Title Recall 228: S80 tire pressure labels,US**Ref No** US23353.1.1 en-US**Issuer** -**Partner** 3 US 7510 Volvo Cars North America**Func Group** 8971 **Func Desc** instruction plate; information plate**Status** Released**Status Date** 2010-07-22**Issue Date** 2010-07-20**Reference** VIDA**Attachment**

Volvo Car Customer Service	
	RTJ Instruction
	RTJ No.23353
	Date July-2010 Issue 01
Title	Recall 228: S80 tire pressure labels,US

Installation:

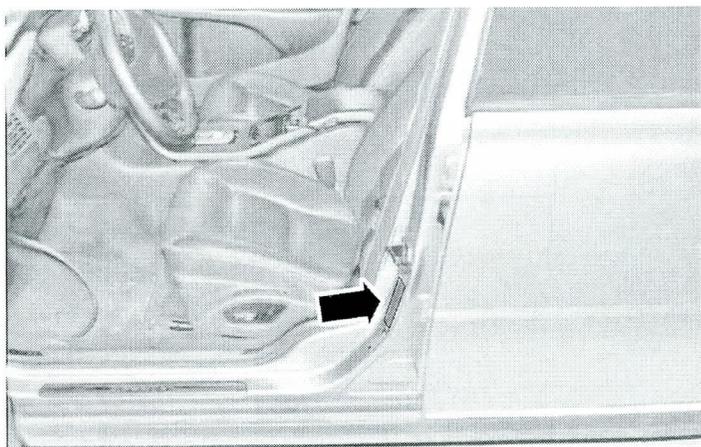
New label supplied by customer

Owners manual upgrade:

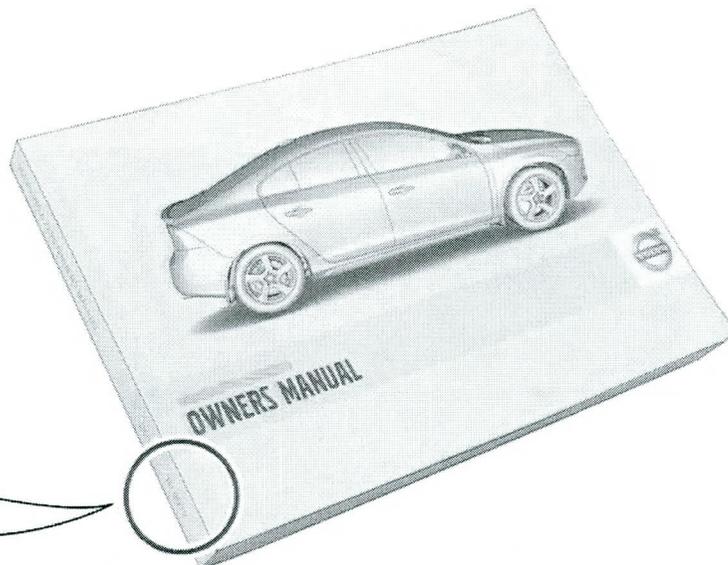
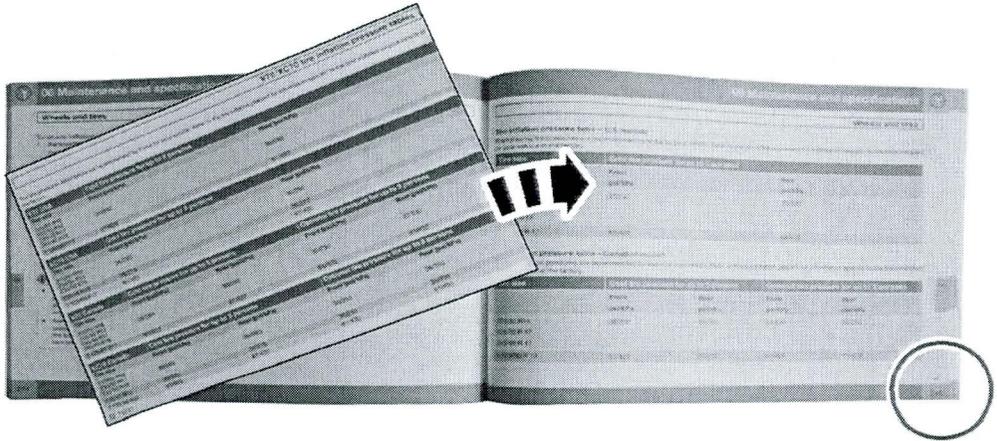
Manual and new label supplied by customer.

TP11451	Page.249
TP8872	Page.221
TP9138	Page.218
TP9549	Page.227
TP9877	Page.240
TP10023	Page.244
TP10682	Page.247
